1.1 Basement Floor Plan Zones 2-5 - Demolition drawings

The following drawings show the amended extent of demolition at Basement Level Zones 2-5 Gridlines W1-W26 of The Western Range Building:

Job Title
 King's Cross Station
 Redevelopment Programme
 Package 6

OAP Job No	Drawing No	Rev
123345-00	WRB-CAP-0021	05

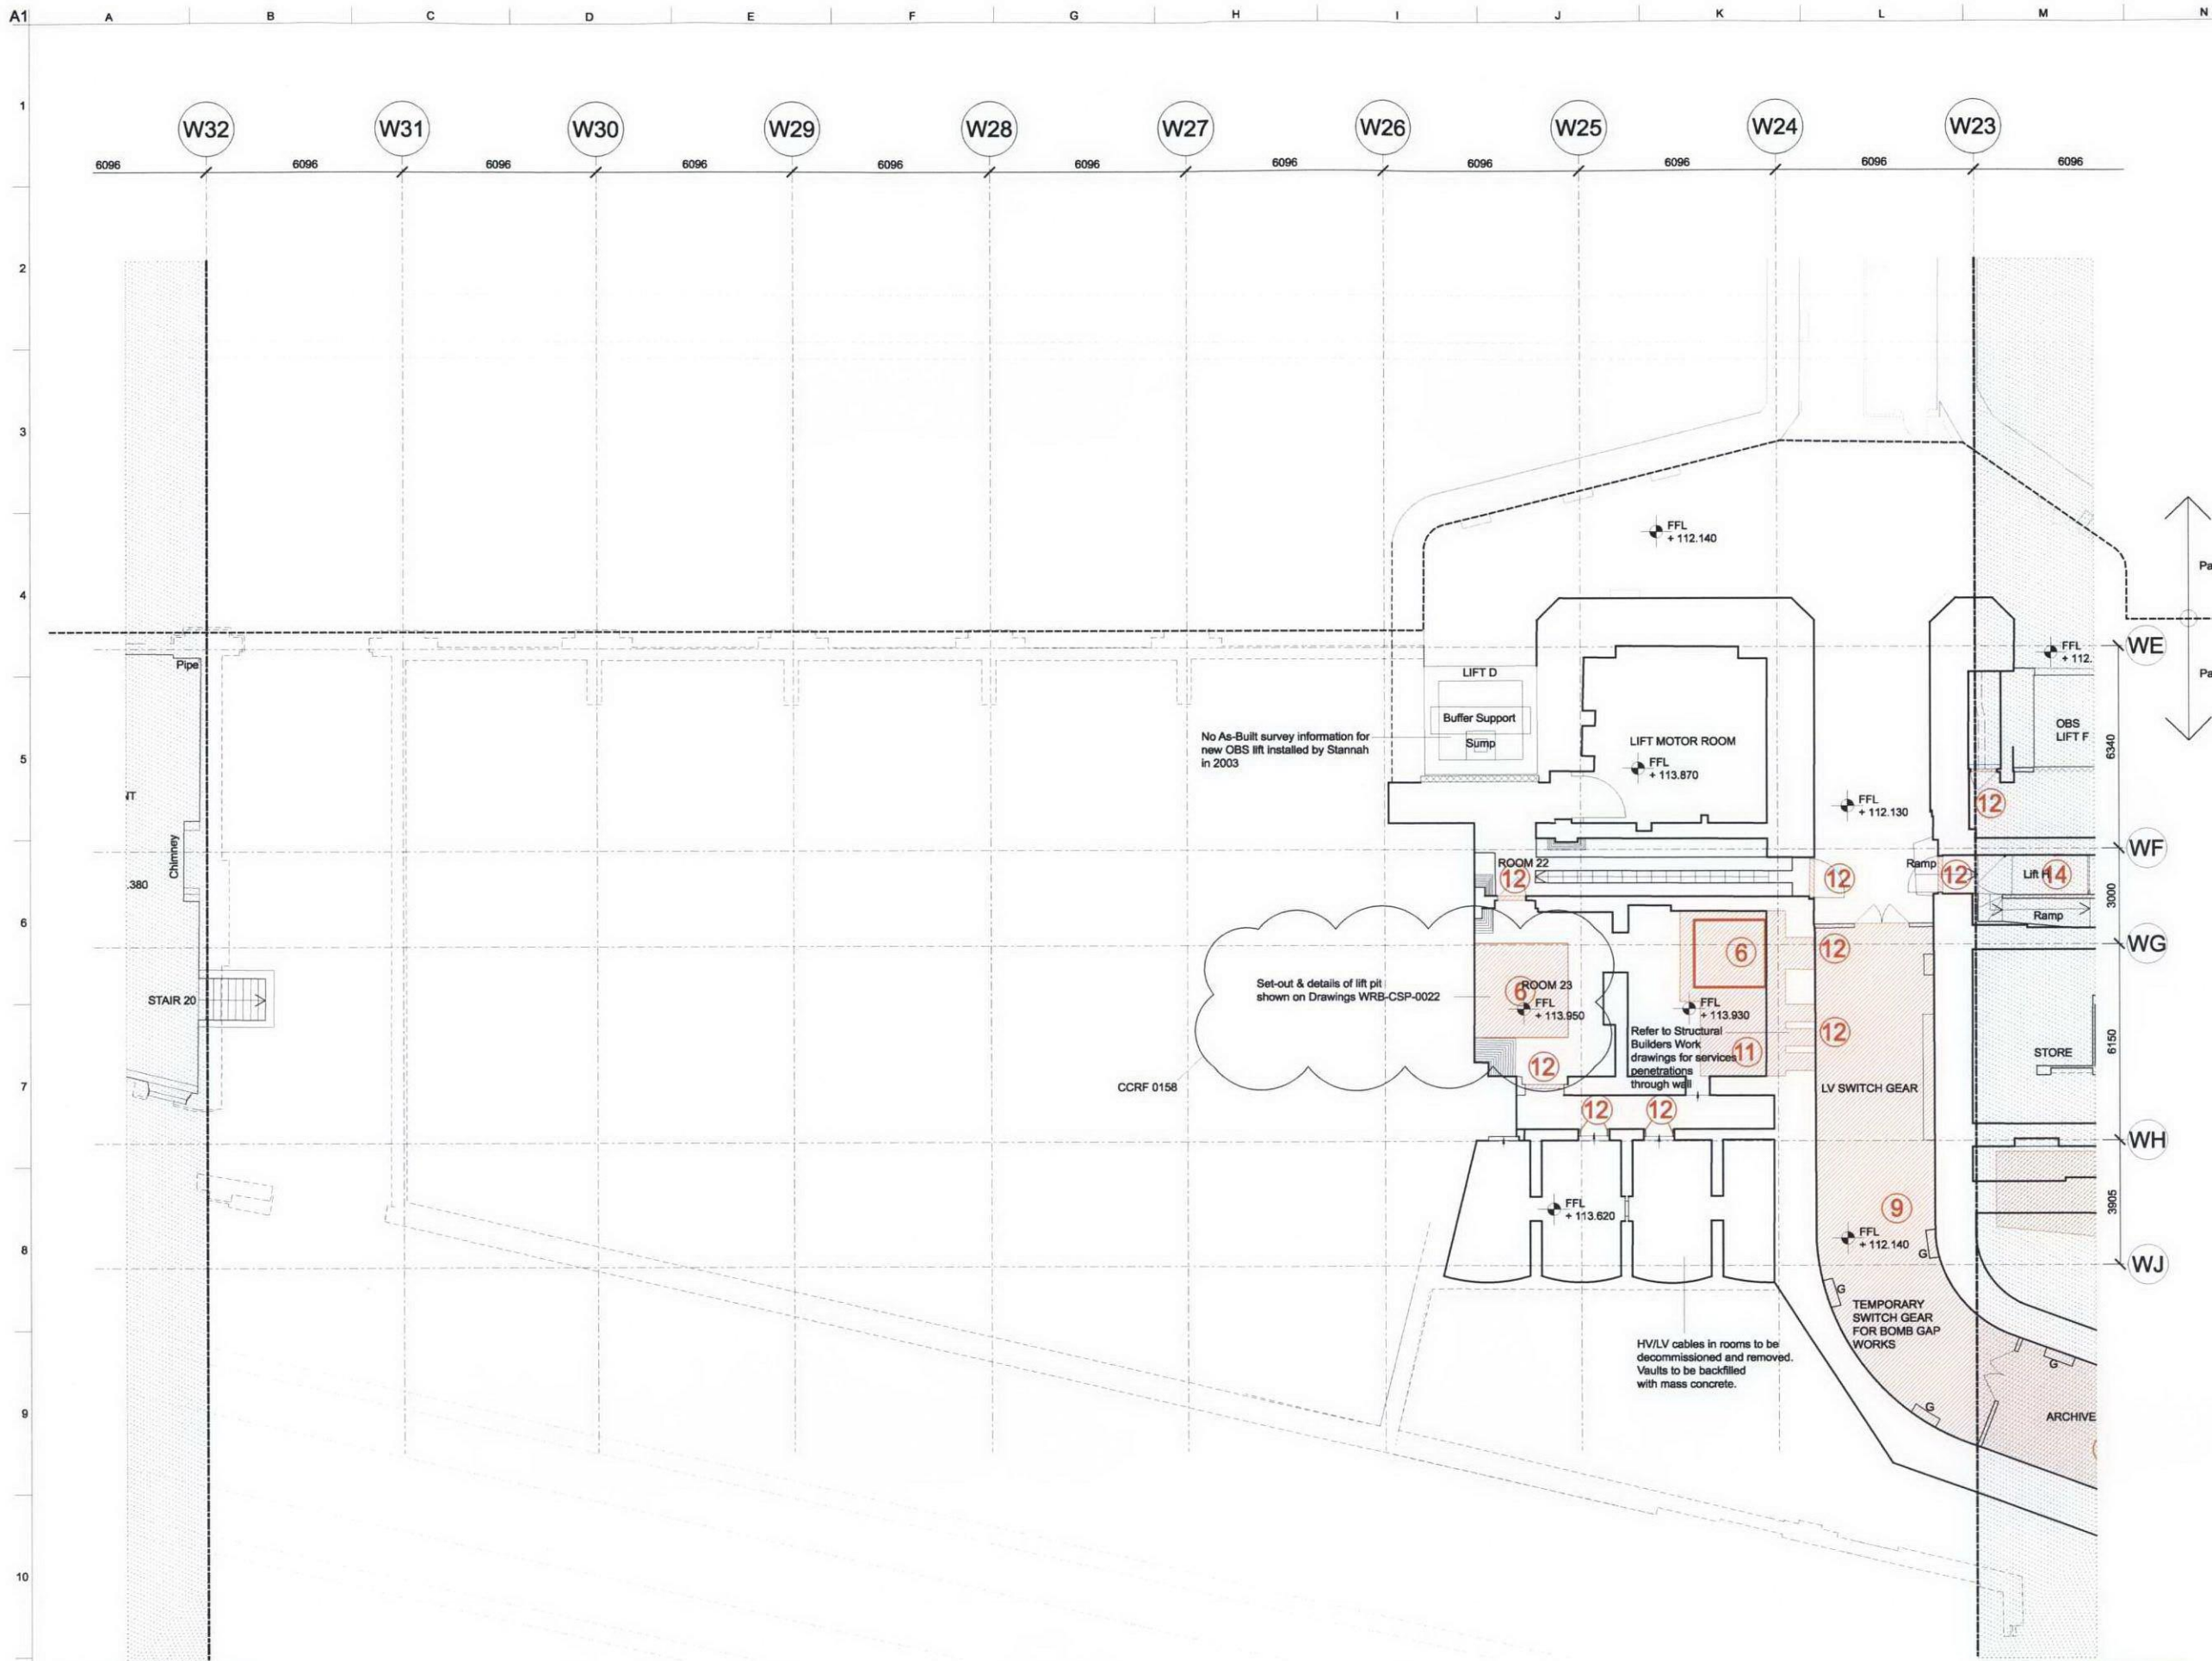
05	23/04/10	JMP	FS	AD
Revised in relation to CCRF 0158.				
04	06/08/09	JMP	GM	AD
Updated in accordance with workshop review records KXBP-PAW-SH-0027 & KX6P-PAW-SH-00023				
03	15/05/09	JMP	GM	AD
Post Value Management coordination issue				
02	29/02/08	JMP	AD	MC
For GRIP 5B Production Information				
01	07/12/07	AS	SS	MC
Issued for GRIP Stage 5A				
Issue	Date	By	Chkd	Appd

OAP Job No. **123345-00** Drawing No. **WRB-CAP-0022** Rev. **07**

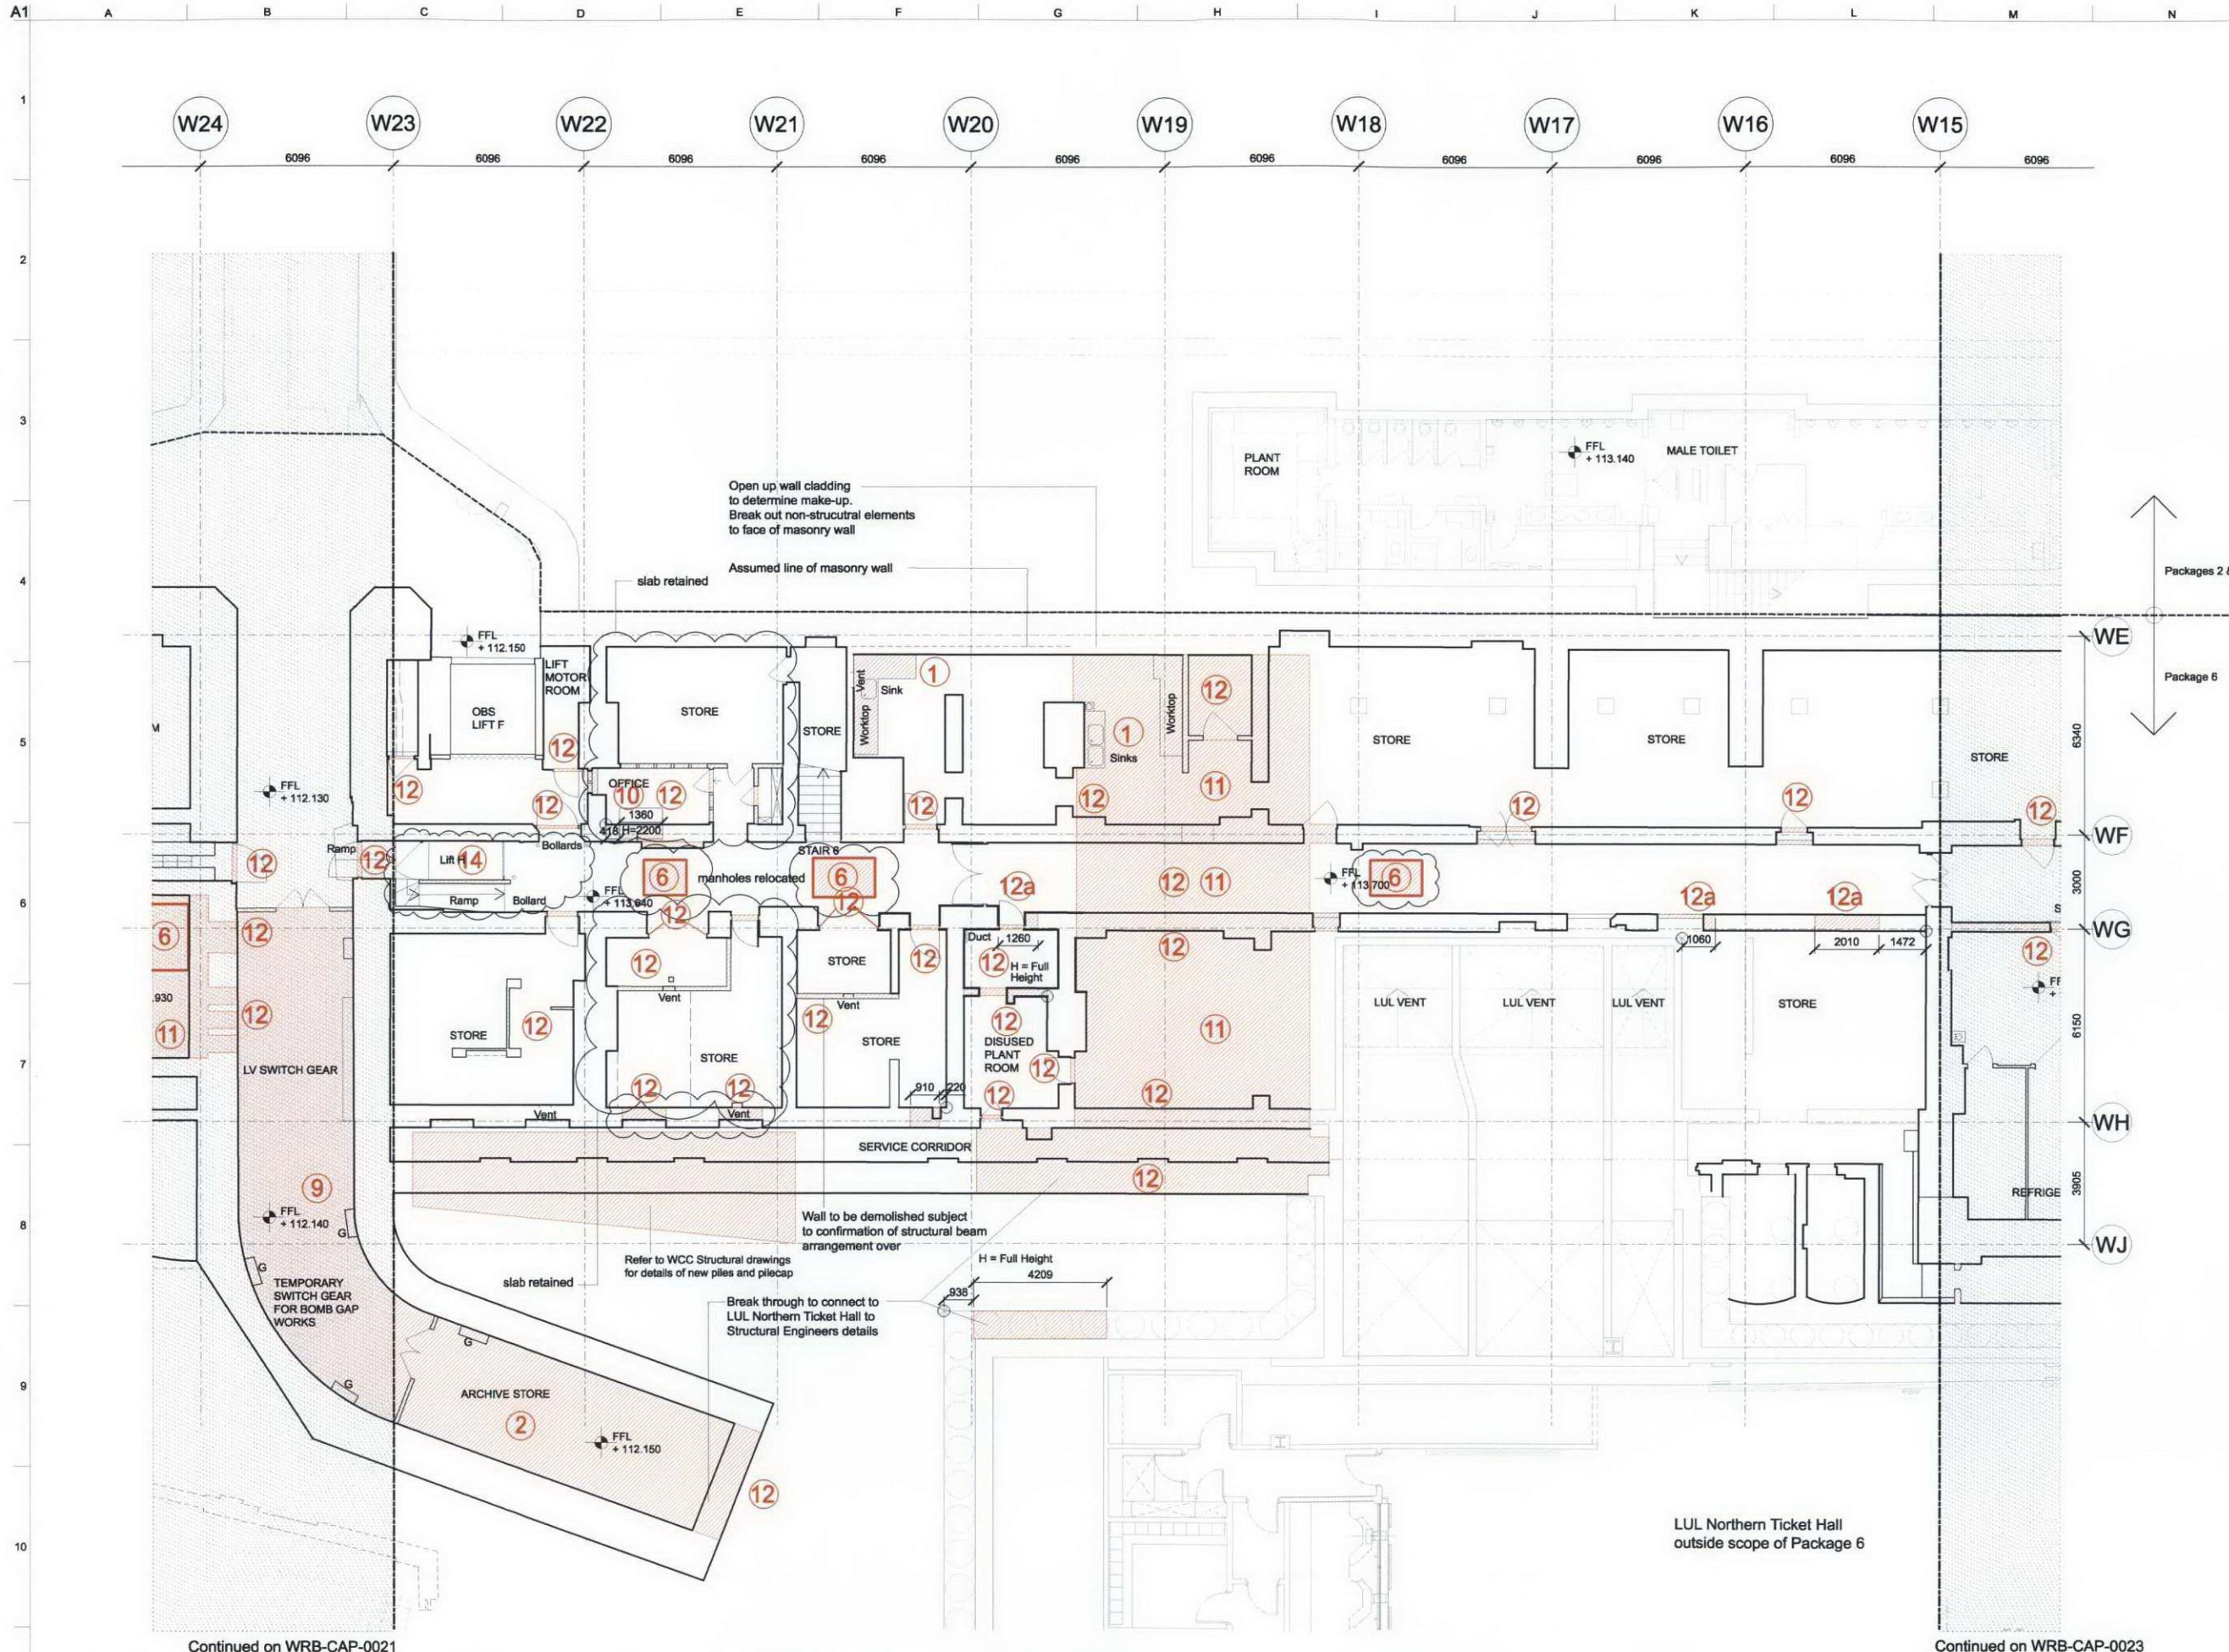
07	23/04/10	JMP	FS	AD
Revised in relation to CCRF 0084				
06	07/08/09	JMP	GM	AD
Updated in accordance with workshop review records KX6P-PAW-SH-0027 & KX6P-PAW-SH-00023				
05	15/05/09	JMP	GM	AD
Post Value Management coordination issue				
04	31/01/09	JMP	SS	AD
Revised in accordance with GRIP 6 Value Management redesign scope				
03	20/06/08	KM	CD	AD
For GRIP 5B Production Information Door opening to be widened as noted				
02	29/02/08	JMP	AD	MC
For GRIP 5B Production Information				
01	07/12/07	GM	SS	MC
Issued for GRIP Stage 5A				
Issue	Date	By	Chkd	Appd
